Product Change Notification

Product Change Notification: E-20-003530

AMPSEAL Sealed Connector System - Header Assembly

TE Connectivity
 NAME: HEADER ASSEMBLY, 23 POSITION, RIGHT ANGLE AMPSEAL
 SIZE: A1 CAGE CODE: 100779 DRAWING NO: 770669
 RESTRICTED TO: 1 OF 2 SHEET REV: K13

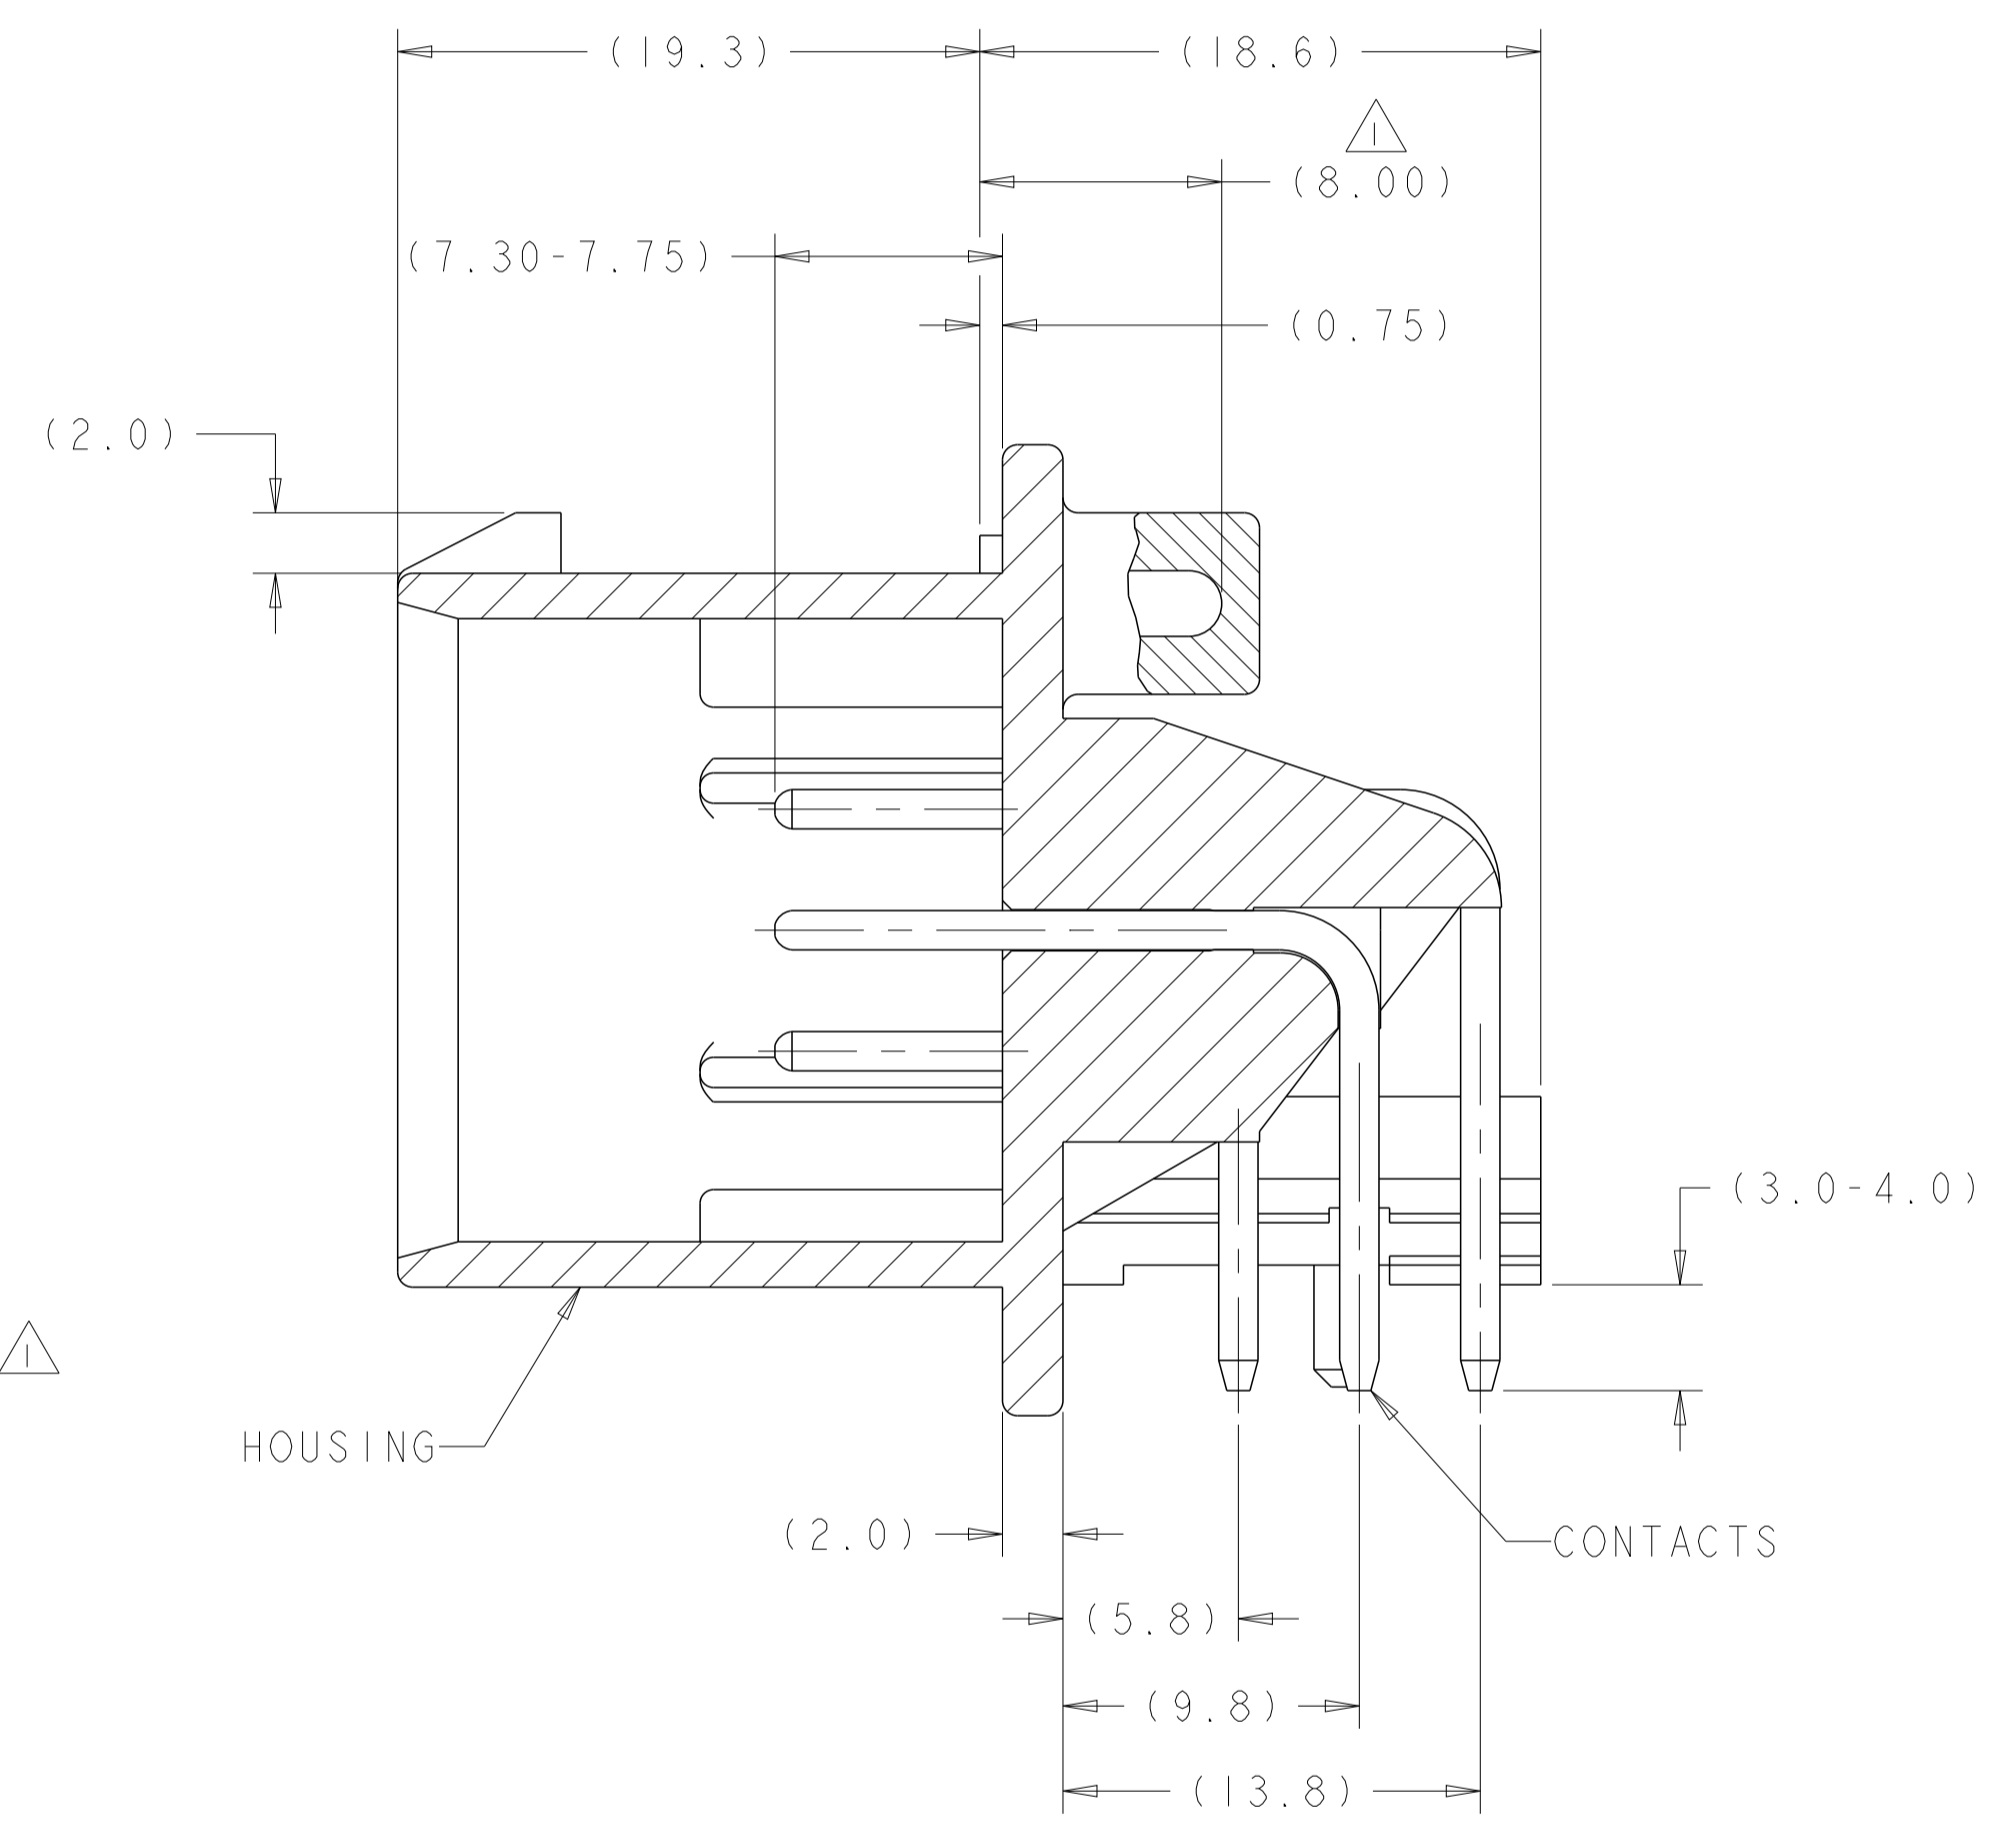
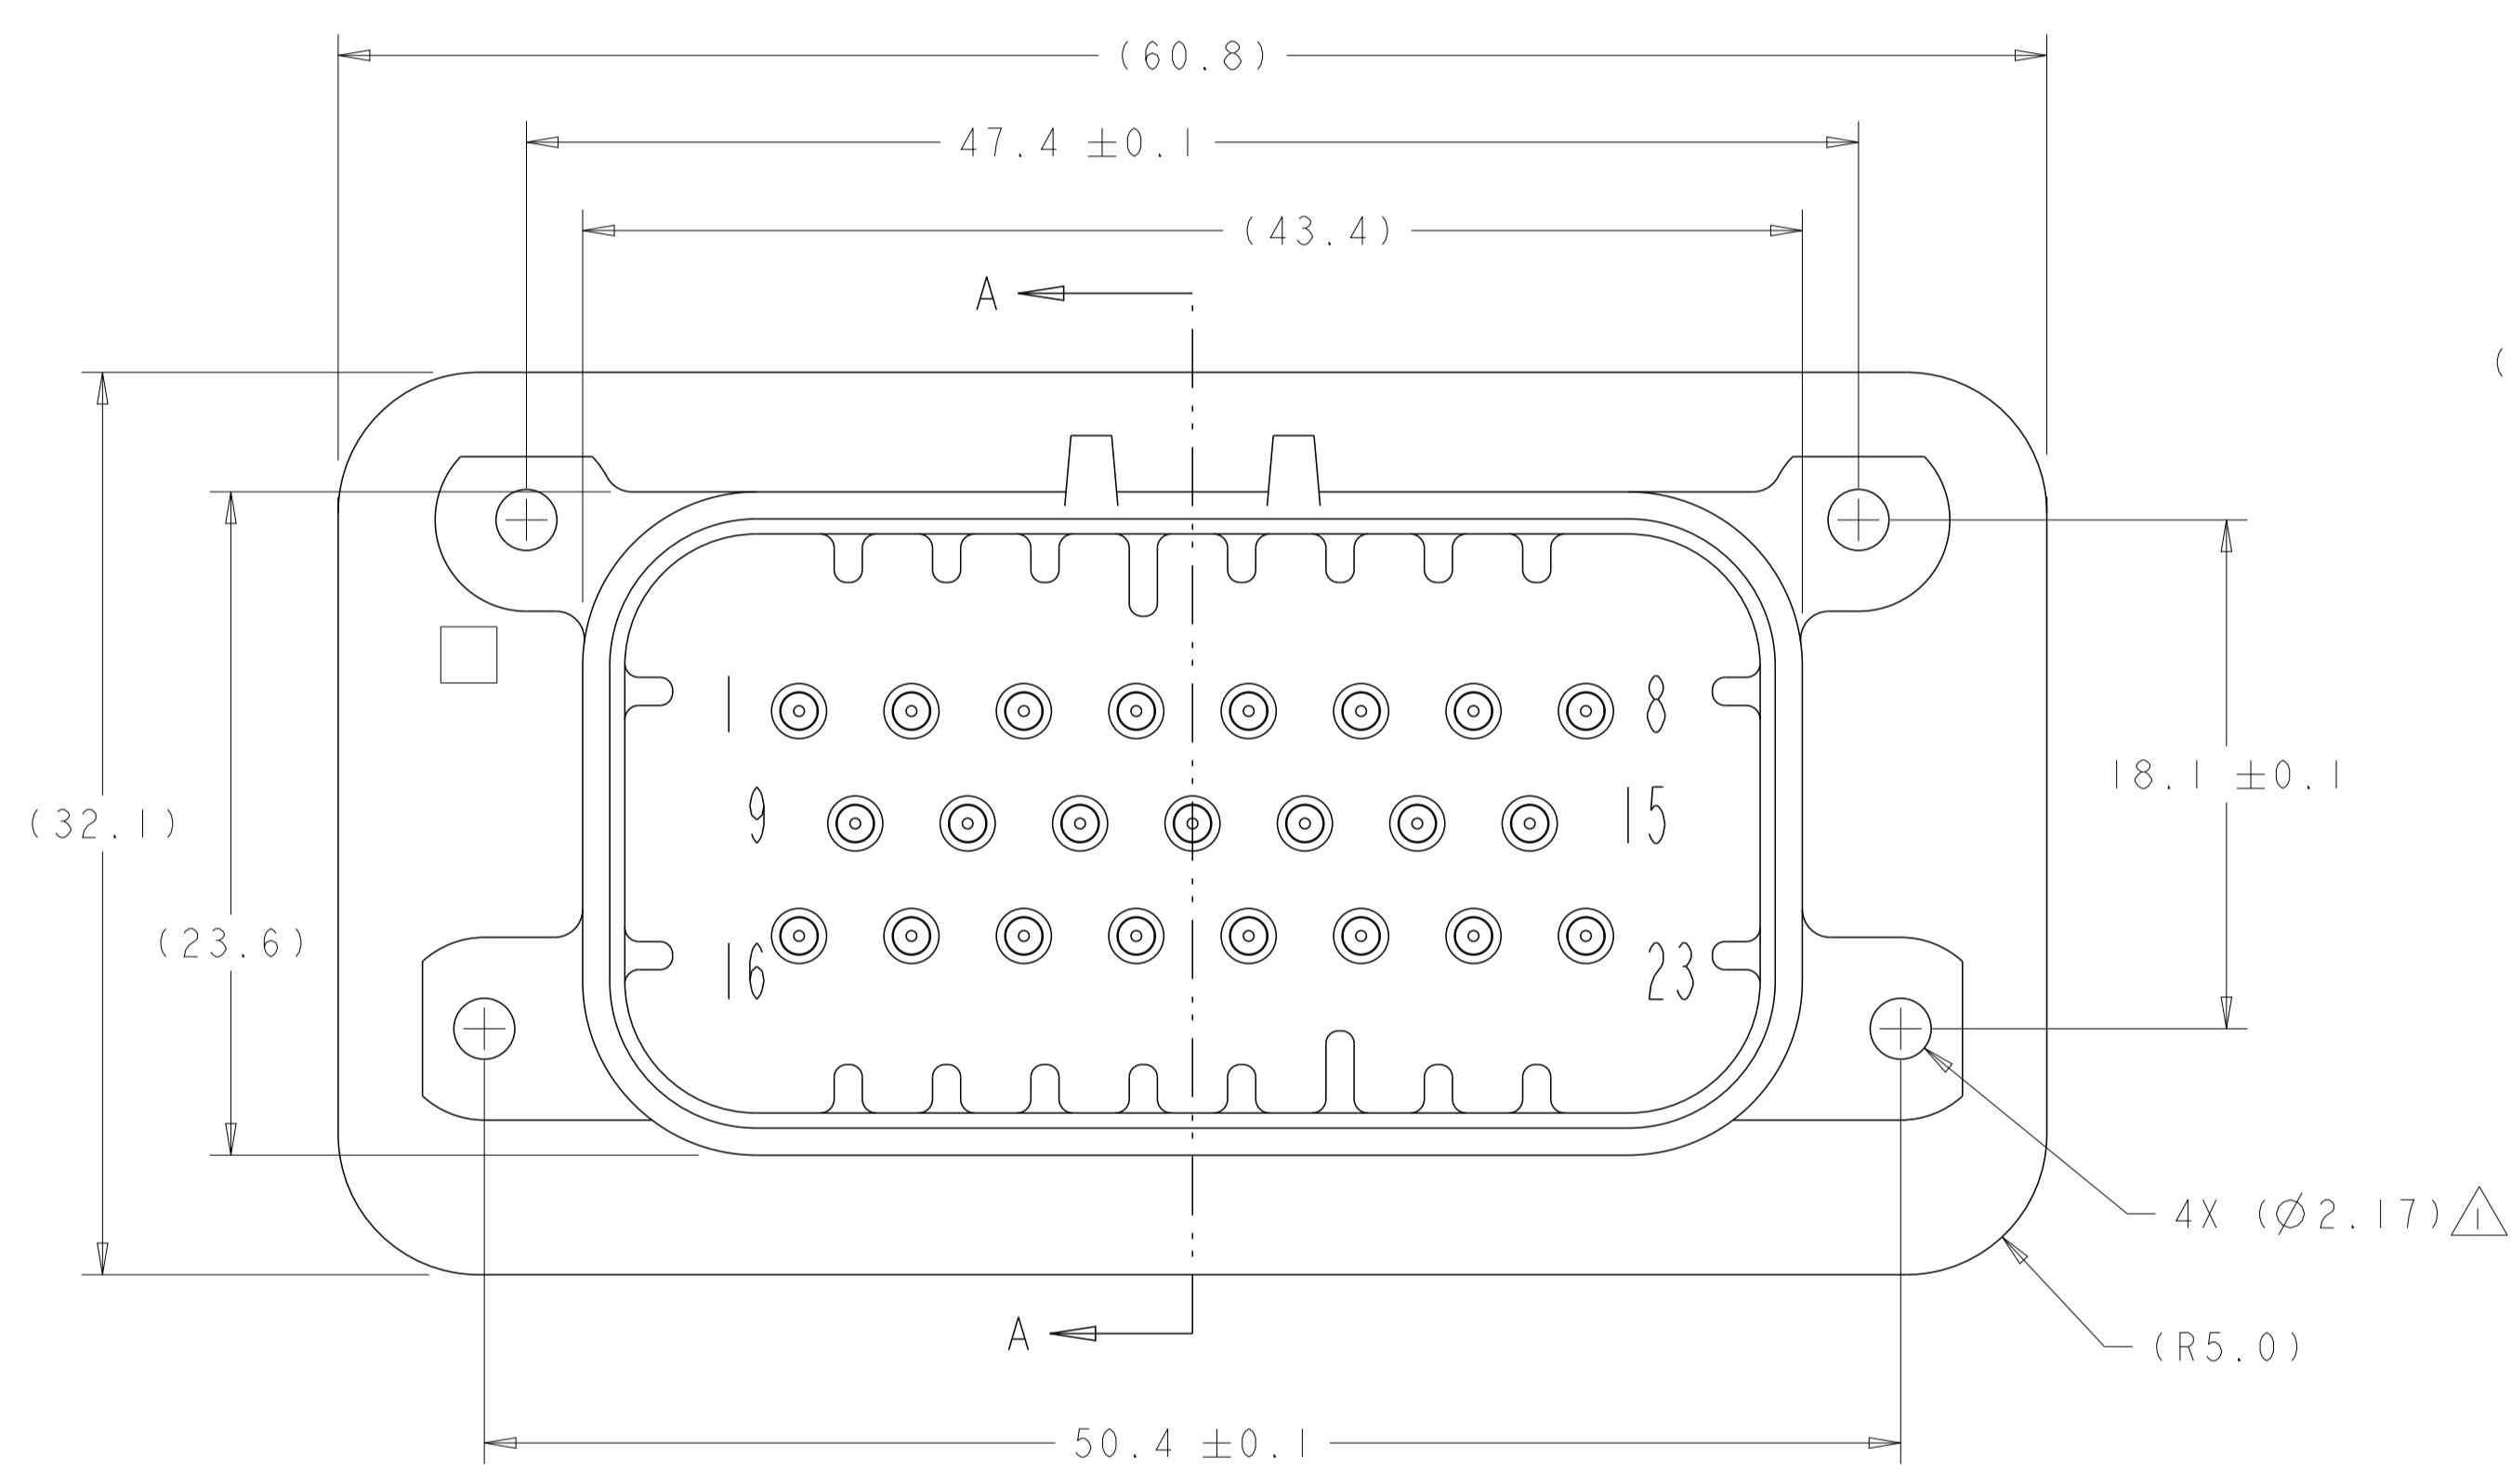
Customer Request. Dear Customer, we hereby inform you of this change. The change is necessary to clarify the information on mounting screw used on the AMPSEAL Header, to modify the mounting hole location dimensions from reference dimension to a tolerance dimension and the suggested mounting hole dimensions will be expanded to aid in the assembly of the header. The change does not impact performance. IMPORTANT: The current and previous revisions of these parts can be used interchangeably in the field.

- 1. SUGGESTED MOUNTING SCREW SIZE IS $\varnothing 2.50-3.00\text{mm}$ [$\varnothing 0.099 - 0.118$ INCH] SELF TAPPING THREAD FORMING SCREW, SUCH AS DELTA PT, TO BE DRIVEN AT 0.6-0.8 N-m. THE CUSTOMER SHOULD TEST THE SCREW SIZE AND TYPE IN ORDER TO VERIFY THEIR SELECTION FOR THEIR APPLICATION
- 2. DATE CODE TO BE BRANDED IN THIS LOCATION PER TE SPEC 102-60. USE 5 DIGIT CODE: FIRST 2 DIGITS = YEAR, SECOND 2 DIGITS = WEEK, LAST DIGIT = DAY
- 3. HOUSING COLORS ARE MECHANICALLY KEYPED TO MATE ONLY WITH IDENTICALLY COLORED PLUG ASSEMBLIES
- 4. MATERIALS: HEADER HOUSING - GLASS FILLED PBT
 PINS: TIN OR GOLD PLATED BRASS
- 5. HEADER MATES TO PLUG ASSEMBLY 770680 WHICH USES REELED TERMINALS 770520 OR LOOSE PIECE TERMINALS 770854
